Thorndon connections cycleway audit - safety and accessibility

90% design audit

Paneke Pōneke
Bike network plan

Figure 4-2: cycleway transition in vicinity of bus stop and pedestrian crossing

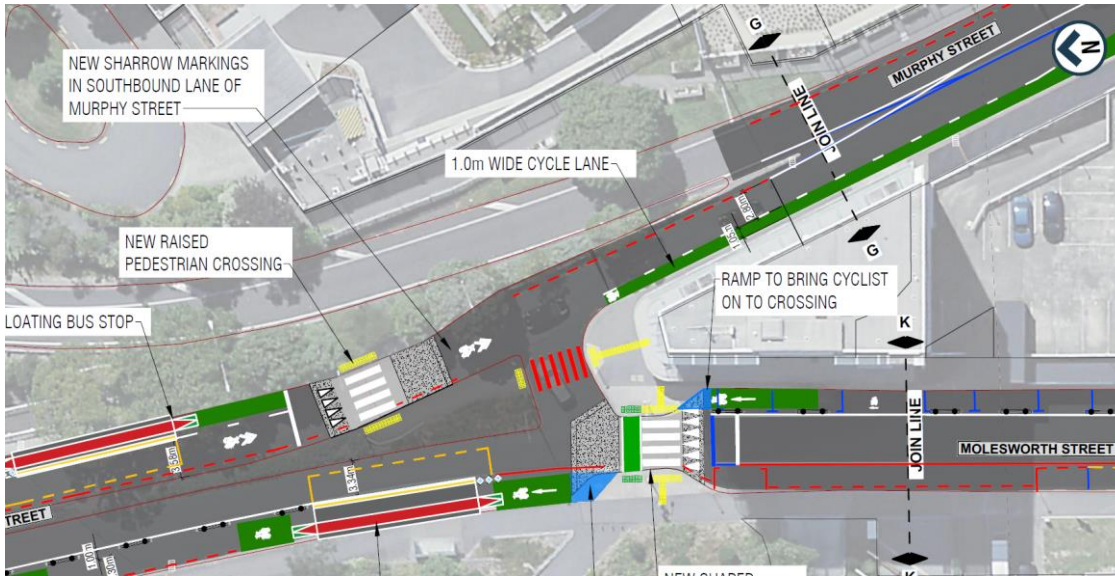
The safety issue is that the merge point for cyclists and motorists appears to be on the pedestrian crossing platform; this could cause confusion for cyclists or motorists and could ultimately result in motorists failing to merge correctly with cyclists or give way to pedestrians on the crossing.

Firstly, shifting the bus stop back has improved the distance available for cyclists and motorists to merge.

The risk factors include large numbers of pedestrians and the presence of the bus stop which is another feature for cyclists and motorists to negotiate.

lane prior to the pedestrian crossing, to avoid having the merge beginning on the crossing itself.

Responses:	
Designer	Agree with the CAT, to amend design of merge
Safety Engineer	Agree with CAT and Designer.
Proposed action	Update plans
Client decision	Agree with Proposed Action

Plans updated

Figure 4-3: narrow cycle lane on Murphy Street

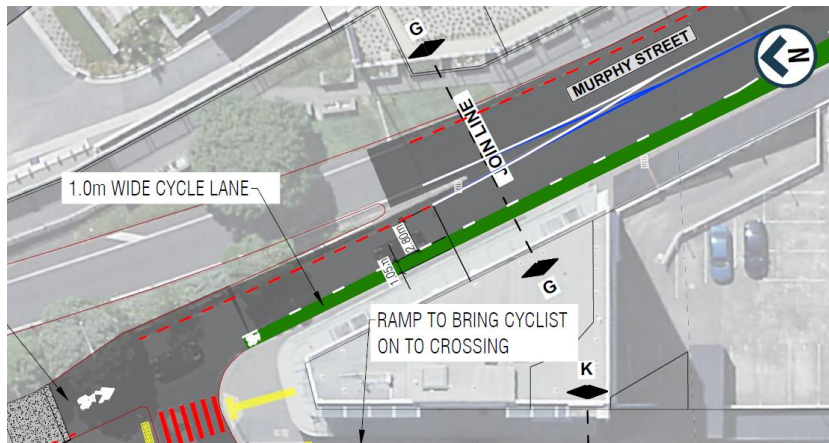
The safety issue is the cycle lane on Murphy Street after the pedestrian crossing (see Figure 4-3) is too narrow.

The risk factors include cyclists and motorists having a false sense of security thinking they each have their own spaces when there is not enough width for this form of provision and the carriageway constraints between the solid median island and the footpath kerb.

The relevant standards are outlined in the CNG section on [cycle lanes](#), which specifies an absolute minimum cycle lane width of 1.4 m (adjacent to a kerb, in low speed environments, for short sections).

4.3.1 Continue the mixed traffic section with sharrowes at least up to the end of the solid median island and begin the cycle lane after that.

Designer	Agree with CAT, to shift start of cycleway further down Murphy St at which point a full width traffic lane and cycleway can be provided
Safety Engineer	Agree with CAT and Designer.
Proposed action	Update plans
Client decision	Agree with Proposed Action
Action taken	Plans updated

Figure 4-4: Mixing lane with defined merging length

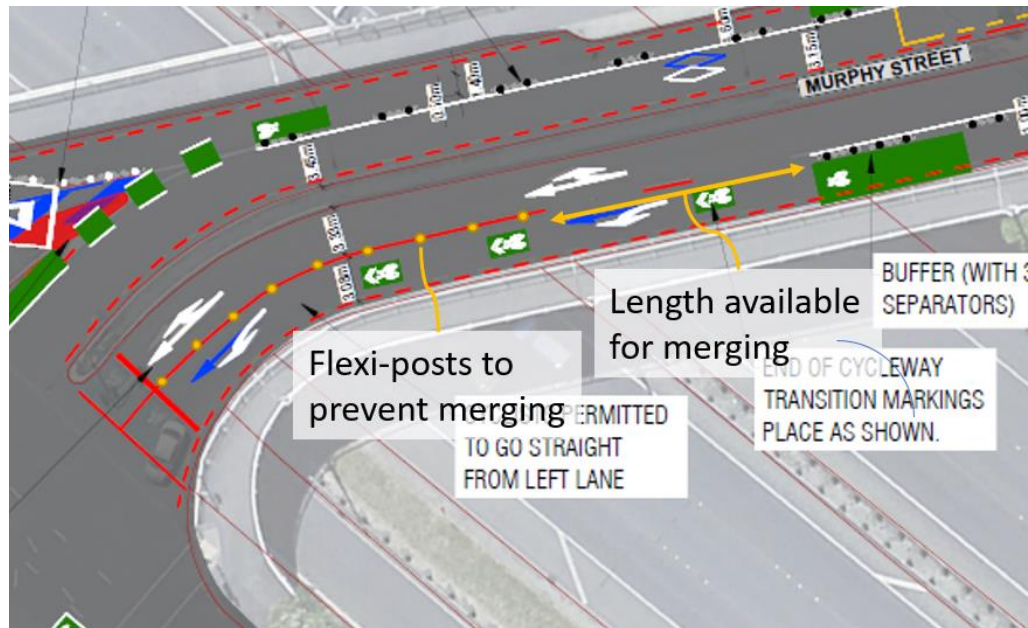
The safety issue is the long section available for merging in the mixing lane on Murphy St approaching Tinakori / Park. This length means drivers can enter the mixing lane at greater speeds, and cyclists are exposed to conflict over a greater distance.

The length of the lane itself is determined by queue length requirements, but it is not necessary that the entire length is accessible to merging vehicles. It would be preferable to reduce the length available for merging to reduce speeds of vehicles entering the mixing lane,

4.4.1	Restrict the merge area of the mixing lanes e.g. by adding flexi-posts along (at least some of) the lane line from the limit line. The extent should be based on vehicle tracking to enter the mixing lane, and vehicle tracking within the lane should also be considered. Figure 4-4 illustrates the concept.
-------	---

Responses:	
Designer	Agree with CAT, to restrict length available for merging
Safety Engineer	Agree with CAT and Designer.
Proposed action	Update plans
Client decision	Agree with Proposed Action
Action taken	Plans updated

Figure 4-5: Likely cyclist non-compliant manoeuvres and resulting conflicts

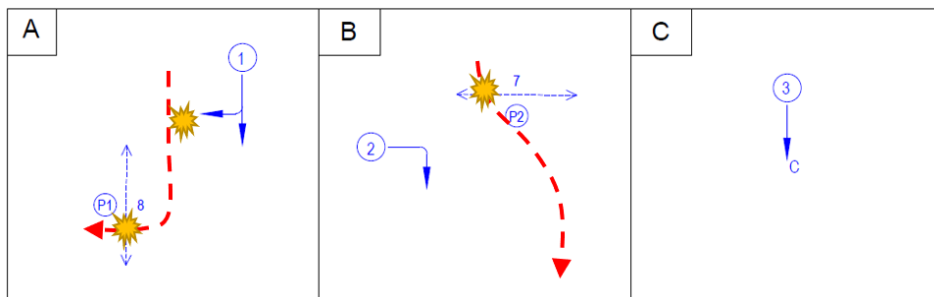
The safety issue is the fully protected cycle movement at this intersection will increase cyclist waiting time, reduce cyclist LOS, and lead to some cyclists undertaking unsafe manoeuvres.

The problem is that, in either the A or B phase, there will be cyclists waiting at the limit line believing that they could progress safely, and some cyclists will choose to run a red light to improve their efficiency – these are illustrated in Figure 4-5. In the B phase, cyclists travelling along Mulgrave Street would be safe to cross on a sharp diagonal, provided they do not conflict with any pedestrians crossing Mulgrave Street. In the A phase, cyclists turning right might do so, but they would risk conflict with any pedestrians crossing Aitken Street and, of greater concern, they would be at risk of being hit by vehicles turning right into Aitken Street.

Furthermore, whilst one cyclist may be able to judge a safe manoeuvre, subsequent cyclists may follow along without adequately judging the situation. For example, a confident right turning cyclist may move in the B phase, knowing they can make it before an approaching right turning vehicle, but the cyclist behind them may not notice the vehicle or judge the

Probability of crash occurring	Unlikely
Expected crash severity	Serious injury
Primary treatment recommendations:	
4.5.1	Provide raised safety platform.
Supporting treatment recommendations:	
4.5.2	Double-cycle the C phase to increase cyclist level of service and decrease the chance of a cyclist waiting at the limit line when there is no conflicting traffic.
4.5.3	Monitor the intersection to better understand cyclist arrival patterns, cyclist route choice through the intersection, extent of non-compliance and any resulting conflicts.

Designer	Agree with CAT, proposed operation of the intersection was to have a short cycle time to reduce wait for cyclists. To consider double running phase C as a way to achieve a similar outcome.
Safety Engineer	Agree with CAT and Designer.
Proposed action	Include in personality creation

Client decision	Agree with Proposed Action
Action taken	Pass to signals team

Figure 4-6: Existing illegal manoeuvre from Kate Sheppard Place eastern end

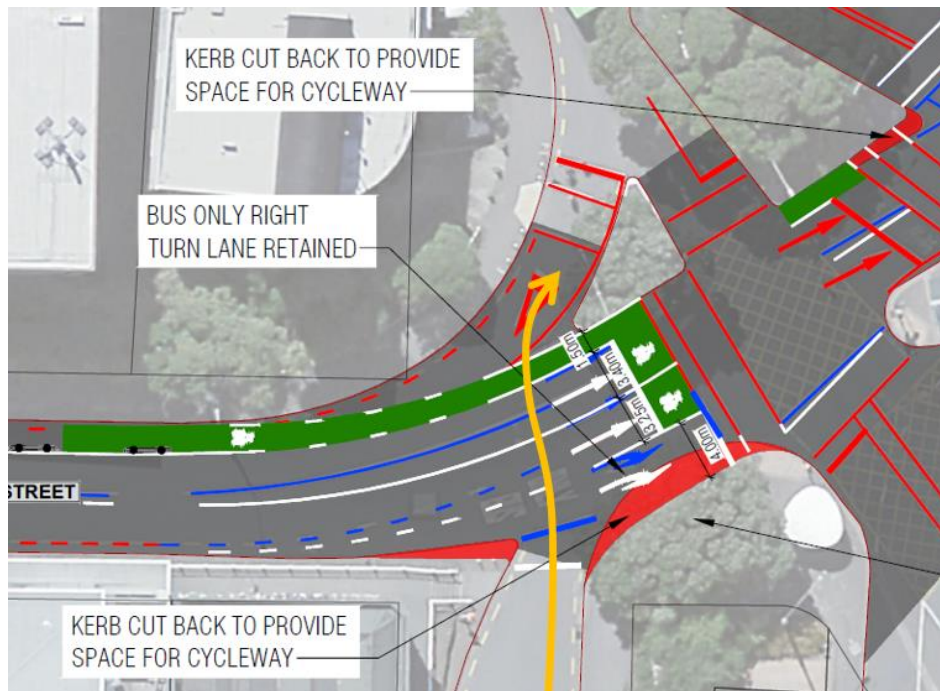
4.7.1	Make the western end of Kate Sheppard Place entry-only from Molesworth Street.
-------	--

4.7.2	Monitor the eastern end of Kate Sheppard Place; if breaches of the right-turn only restriction increase, request additional police enforcement.
-------	---

4.7.3	Consider physical devices that make the illegal movement more difficult, e.g. flexiposts on the edge of the cycle lane.
-------	---

The CAT acknowledges that adding the cycle lane would worsen the consequences of this existing illegal manoeuvre, as drivers then have an additional lane to cross and cyclists are more vulnerable than motorists. However, we suggest that the risk to the cyclists on Murphy Street would not be as great as the risk to the contraflow cyclists on Molesworth Street, as the Murphy Street cyclists are travelling in the same direction as the general traffic and therefore more likely to be seen the drivers exiting Kate Sheppard Place. Furthermore, it

would be easier to enforce the right-turn only out of the eastern end of Kate Sheppard Place than to ensure drivers turning right out of the western end look for contra-flow cyclists.

Responses:	
Designer	Agree with CAT to make Kate Sheppard Place one-way
Safety Engineer	Agree with CAT and Designer. Kate Sheppard Place to be one-way EB. Consider flexi-posts on the edge of the cycle lane to discourage illegal crossing manoeuvre from Kate Sheppard access the Mulgrave left turn into Lambton Quay/Thorndon Quay. Movement to be monitored and additional enforcement requested as necessary.
Proposed action	Update plans and monitor
Client decision	Agree with Proposed Action
Action taken	Plans update add to monitoring list

Figure 5-1: Different chicane designs on Hill Street

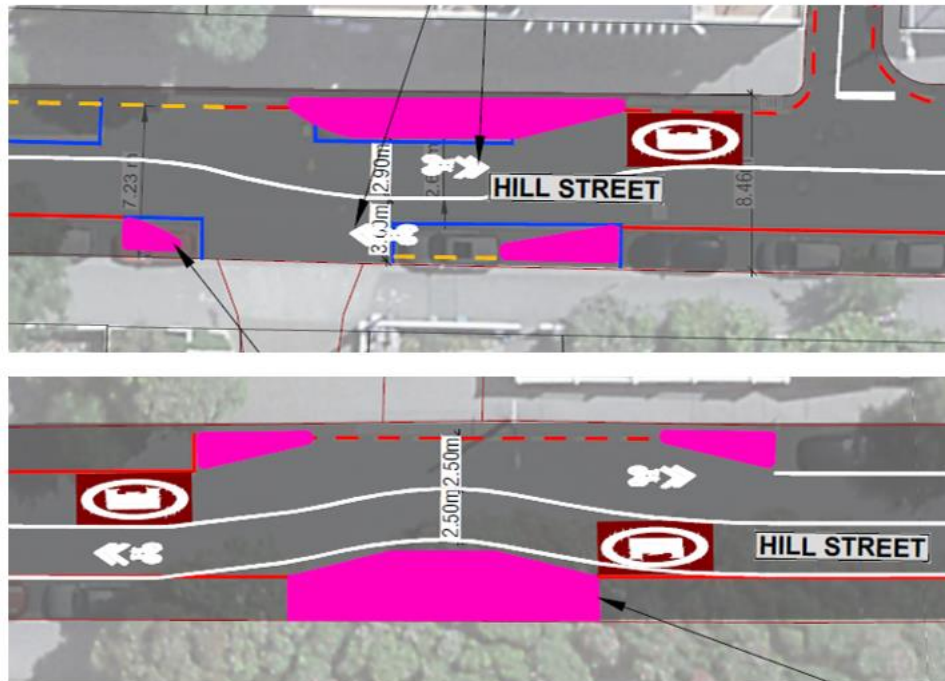
The two chicanes on Hill Street employ different marking layouts regarding the use of the 30 and sharrows markings (Figure 5-1). It would be preferable to have a consistent design.

Probability of crash occurring	N/A
Expected crash severity	N/A
Indicative recommendations:	
5.2.1	Locate the 30 markings at the start of the chicanes (as per the design west of Eccleston Hill) – to ensure drivers approach at a suitable speed.
5.2.2	Locate the sharrows at the mid-point of the chicane (as per the design west of Selwyn Tce) – to remind drivers that cyclists share this street.

Responses:	
Designer	Agree with CAT to amend markings
Safety Engineer	Agree with CAT and Designer.

Proposed action	Speed humps are now being used not chicanes as more effective traffic calming
Client decision	Noted and accepted
Action taken	Plans updated

Figure 5-2: Gap between limit line and pedestrian crosswalk

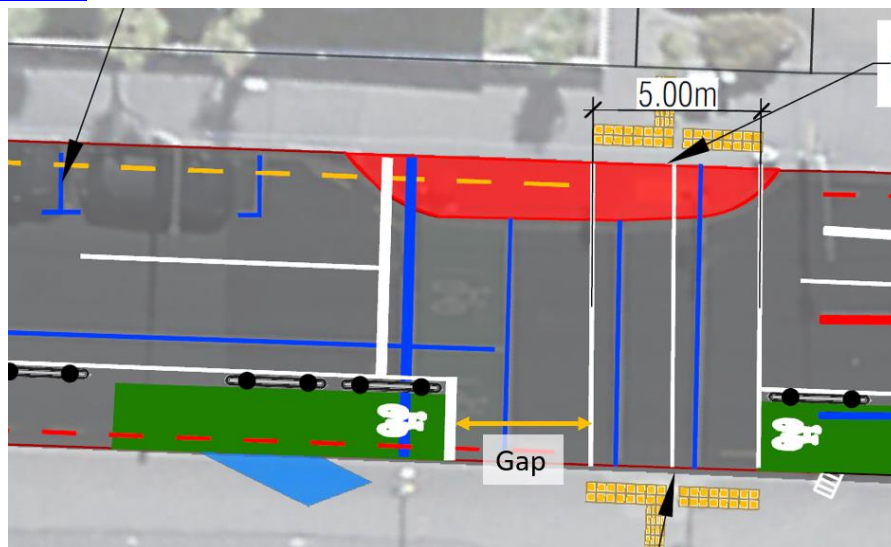
There is a large gap between the advanced stop line and the pedestrian / cycle midblock crossing line; this is only required to be 200mm – see CNG section on [cyclist waiting facilities at intersections](#).

- 5.3.1 Reduce the gap between the limit lines and the pedestrian / cycle midblock crossing line.

Designer	Agree with CAT, to shift cycle limit line
Safety Engineer	Agree with CAT and Designer.
Proposed action	Update plans

Client decision	Agree with Proposed Action
Action taken	Plans updated
